## Submissions Report SSD-11429726

26-42 Eden Street and 161-179 Princes Highway,  
Arncliffe  
Eden Street Communities Plus

Submitted to Department of Planning, Industry  
and Environment

8 February 2022 | 218757

**Figure 2** Photomontage of SSD-11429726 (as proposed to be amended) looking north west from the Princes Highway

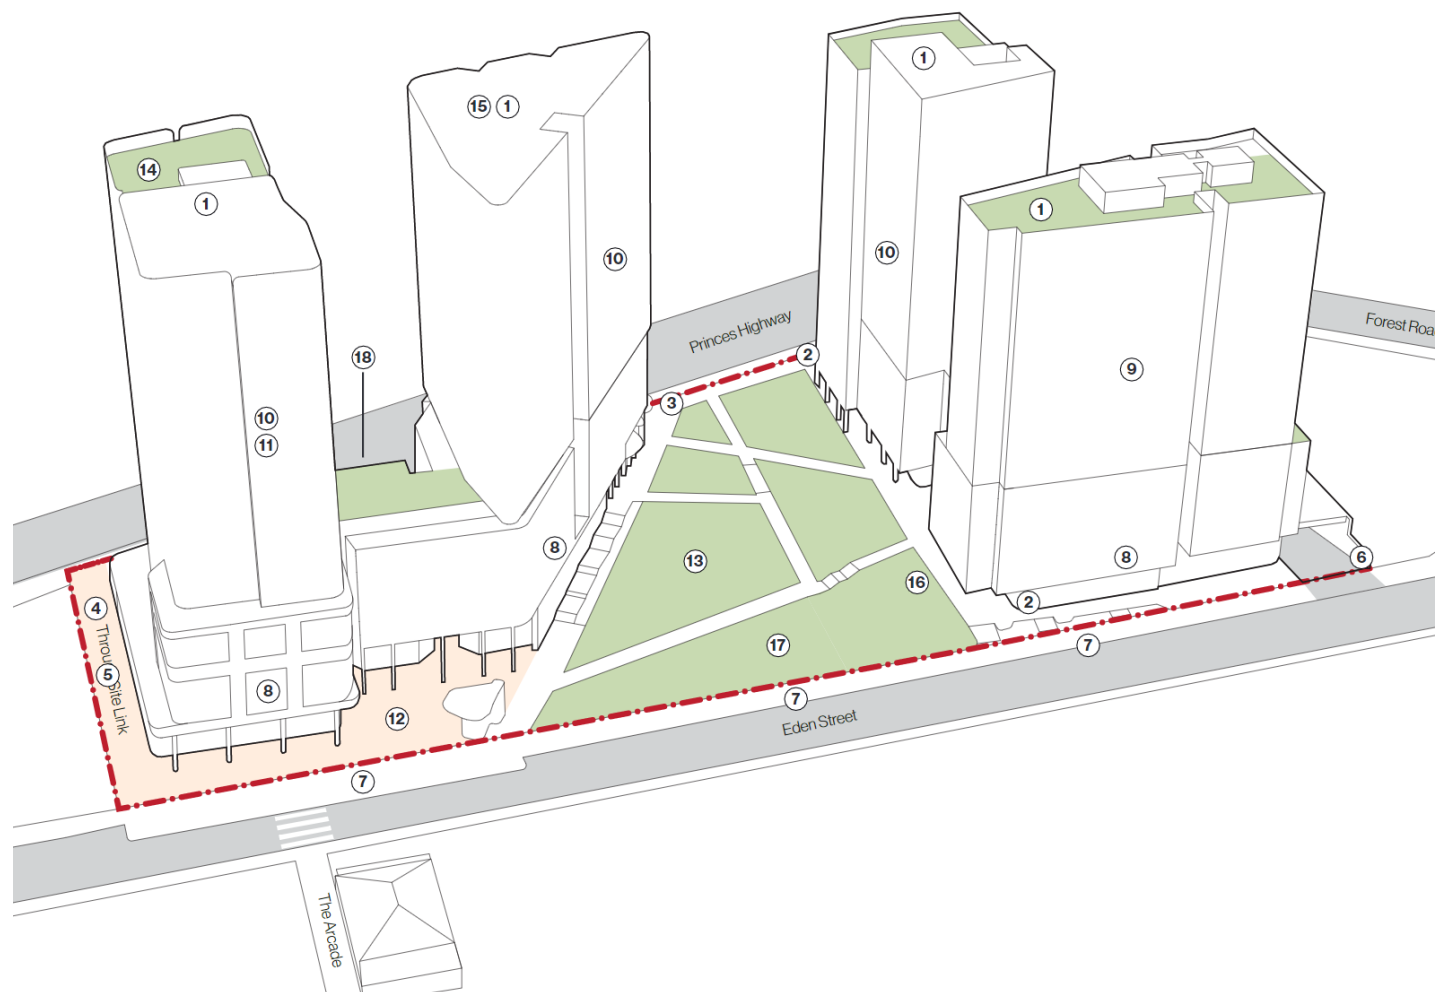
- Buildings A and B have been reduced in height to comply with the site's 70m height limit, excepting a minor 1.5m exceedance for the Building B lift overrun. An additional storey has been added for Building C, while remaining below the 70m height limit (**Section 4.1**);

The proposed amendments are illustrated in **Figures 2 – 5** and described in detail in the following subsections of this Submissions Report. A numerical comparative summary is provided at

**Figure 12** Princes Highway elevation, as amended  
*Source: Group GSA*

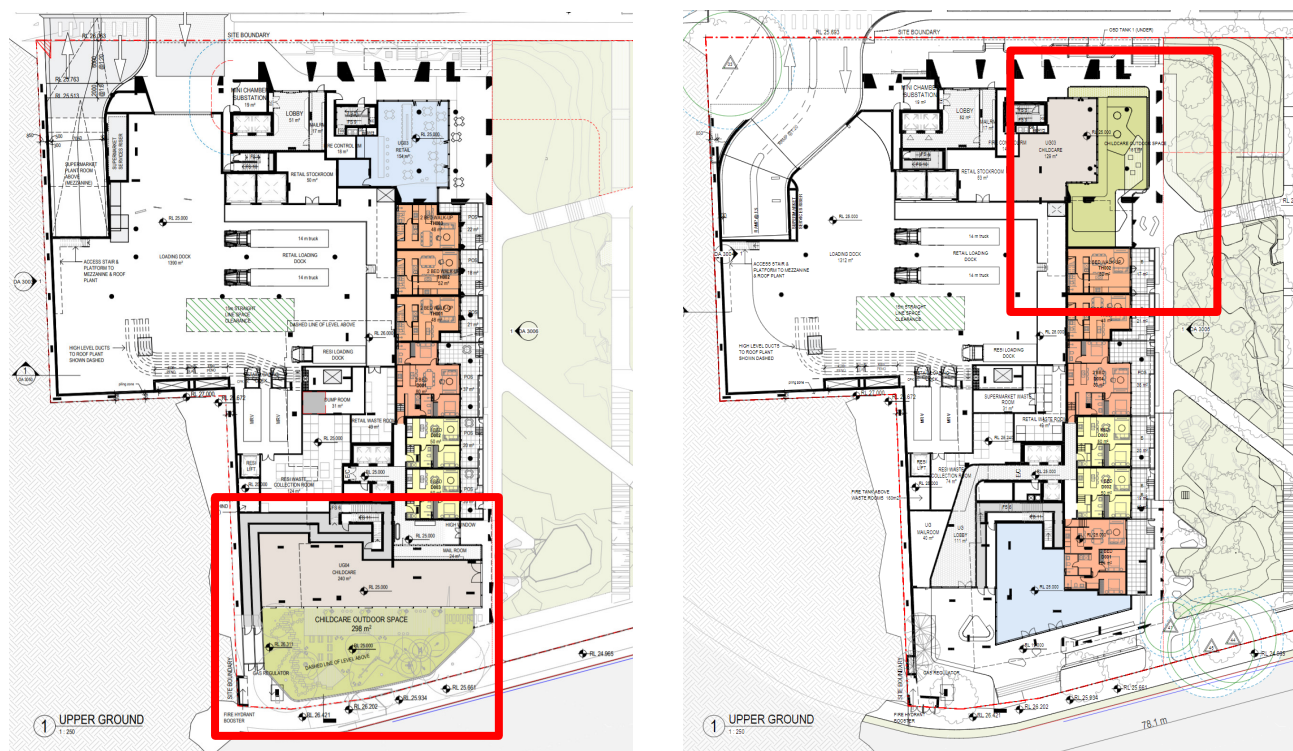
Artist's impressions of the revised facades are provided in **Figures 9 – 12** below.

**Figure 14** Soil area, as exhibited

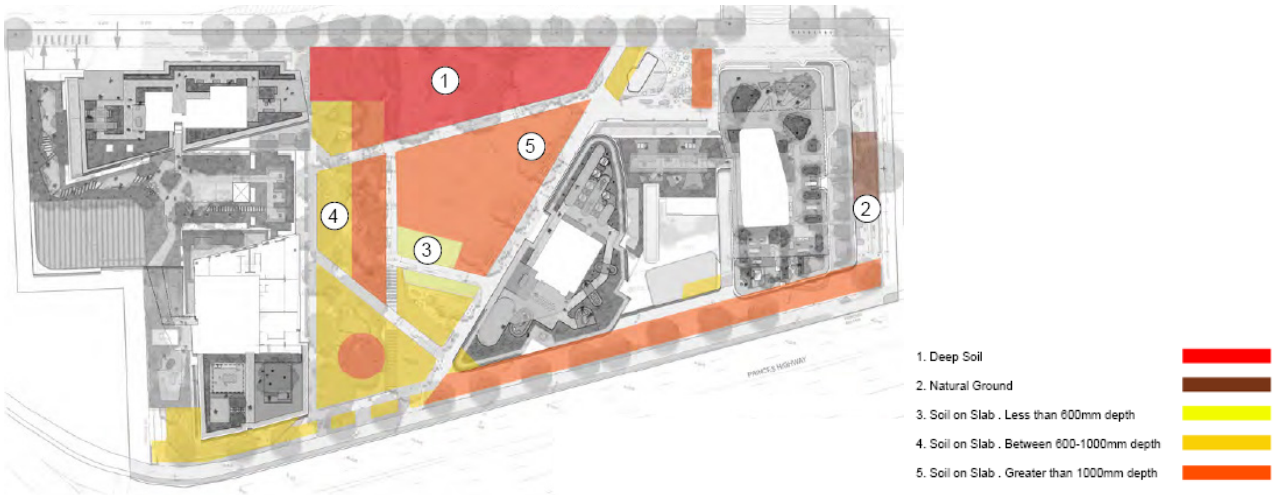
13% of the site is now either deep soil (8%) or 'natural ground' (5%), and 33% of all site area is of soil depth adequate to support tree planting. This significantly exceeds requirements for deep soil under SEPP ARH (>15% of site area to support tree or shrub planting).

The proposed amendments which are illustrated in **Figures 14 – 16**.

**Figure 20 Meeting Place design, as exhibited**

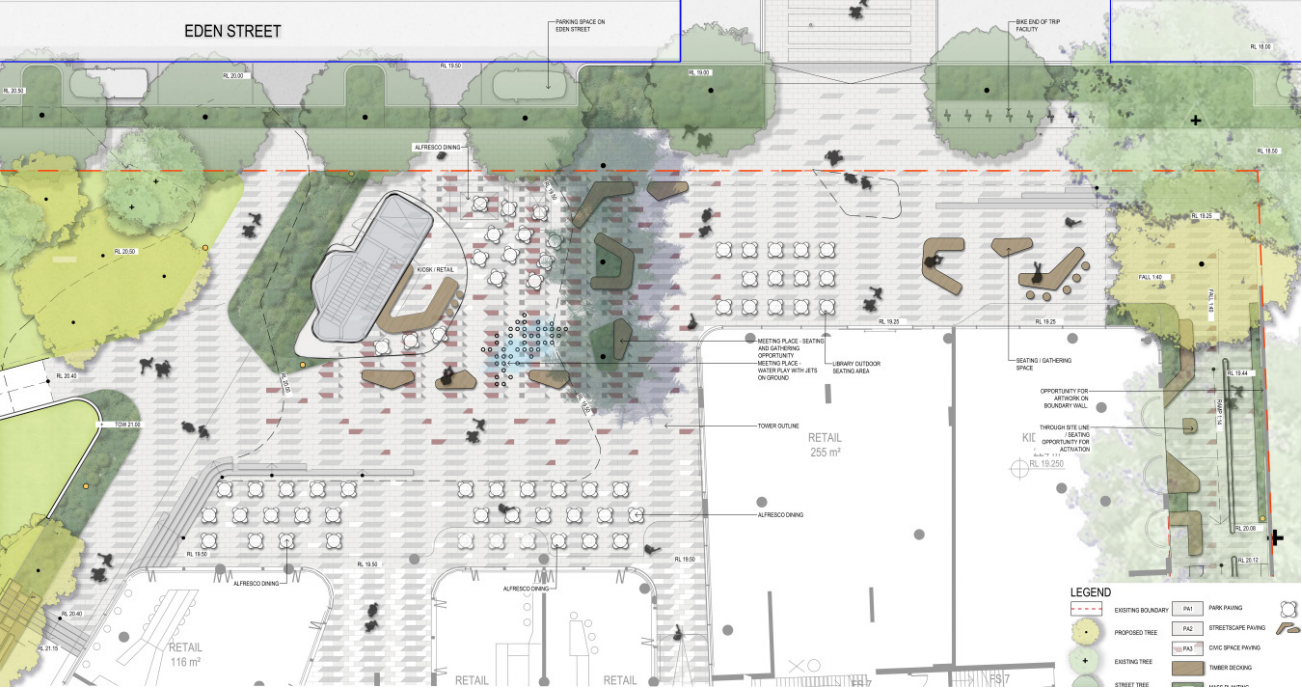
Amendments are proposed to the design of the ‘Meeting Place’ public plaza. The informal outdoor seating and planting has been reconfigured to create an open flexible area adjacent to Eden Street for community events and to provide for greater integration between Building A and the public domain. The kiosk area has also been amended to incorporate embedded and tiered landscaped elements. The exhibited plan and proposed amendments are illustrated at **Figures 20 – 21**.

**Figure 23** Eden Street driveway configuration, as amended

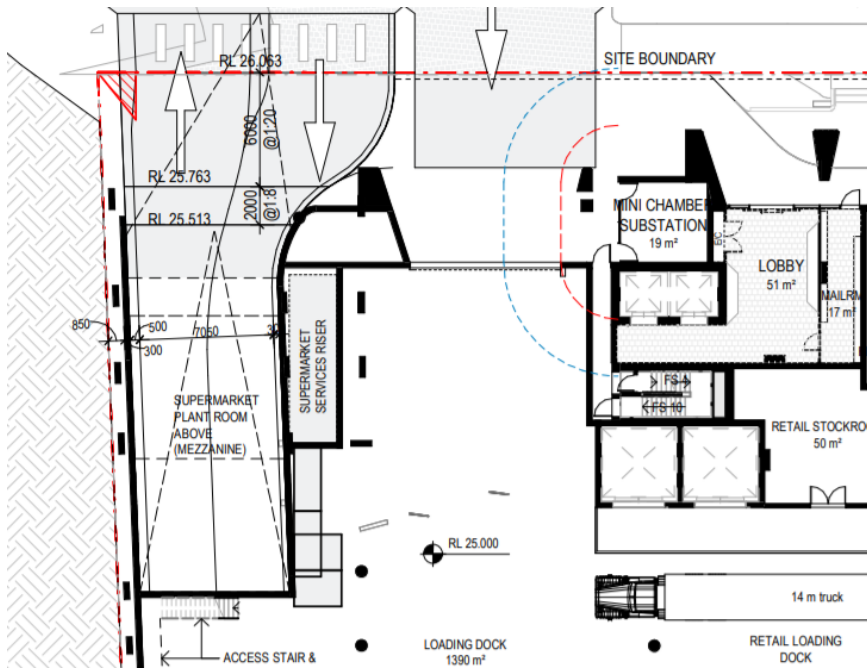
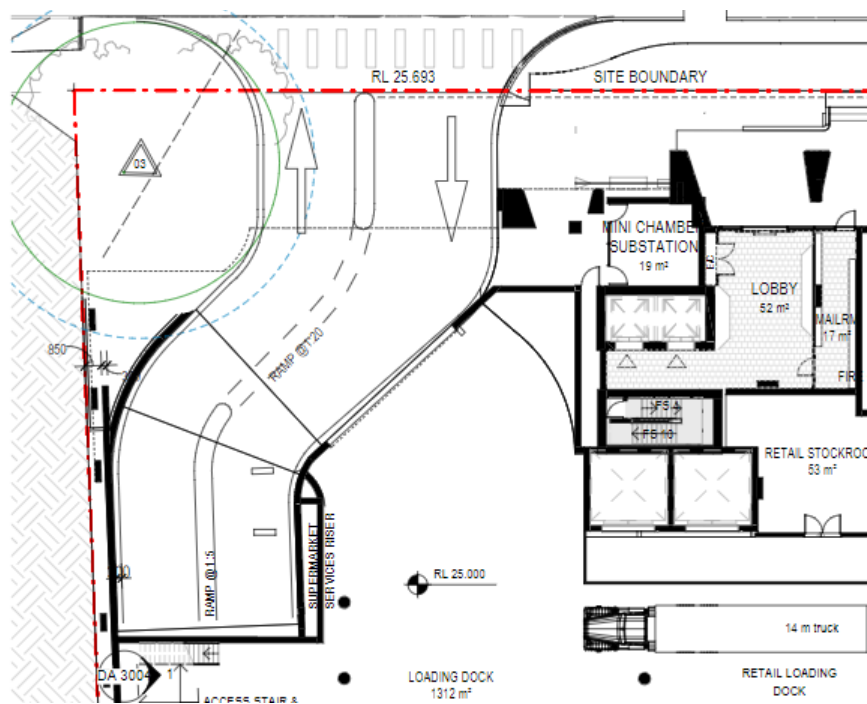
The Eden Street driveway has been reconfigured to provide a single entrance and exit point shared between the basement and loading dock (refer to **Figures 22 – 23**). The reconfiguration reduces the width of the driveway (from 29m to 12.3m) to improve public domain amenity for pedestrians, enables the retention of Tree 3 on the site's southwestern corner, and locates the site's entrance a greater distance from the bend in Eden Street.

**Figure 25** Princes Highway frontage as amended, with new vehicular entrance (red)

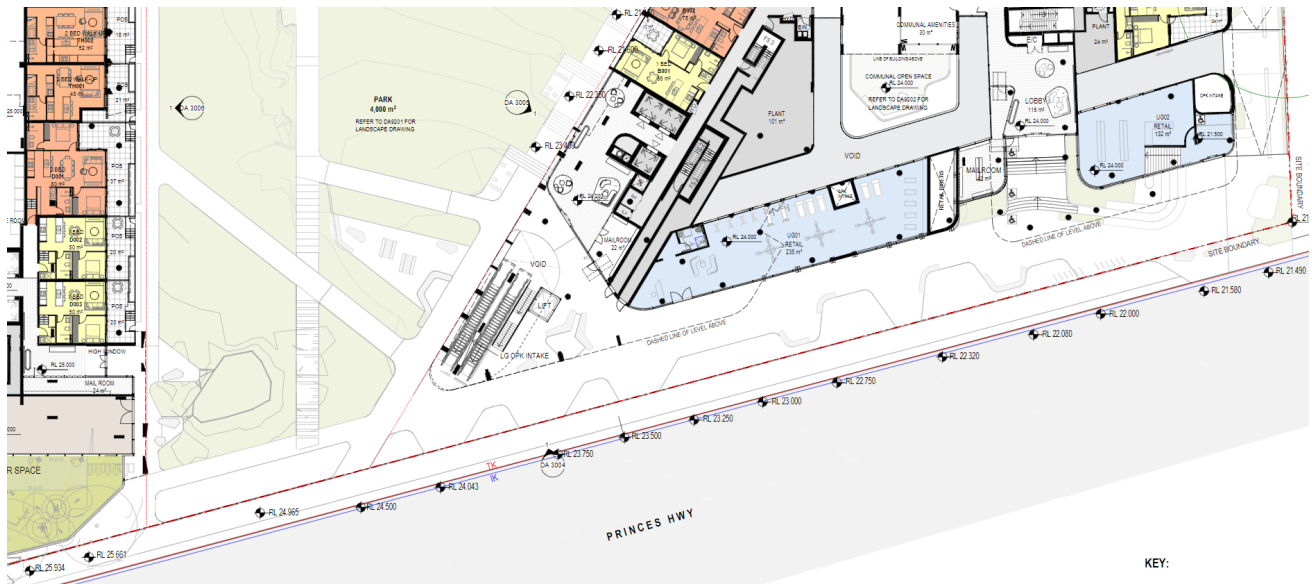
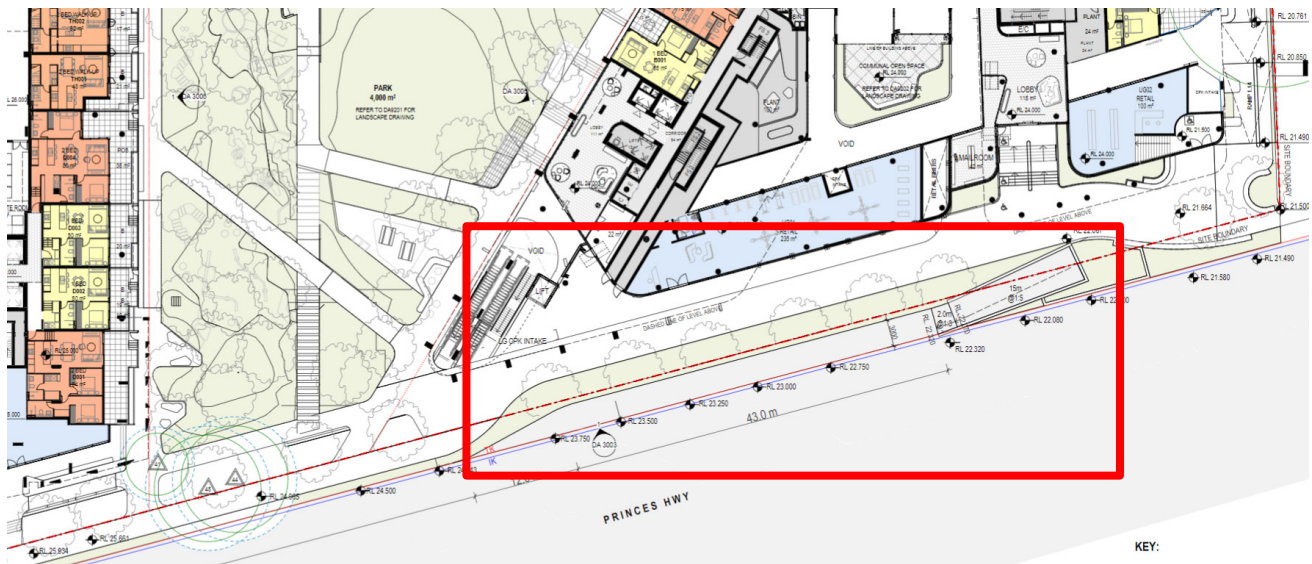
A new deceleration lane and left-in only basement entrance is proposed from the Princes Highway (refer to **Figures 24 – 25**). The Princes Highway access will improve access to the development for vehicles coming from the south on Princes Highway or east on Wickham Street. It removes the need for vehicles coming from the south and east to access the site via the local road network (Eden Street via Burrows Street), which will reduce the volume of traffic on the local roads and improve the amenity of Eden Street.
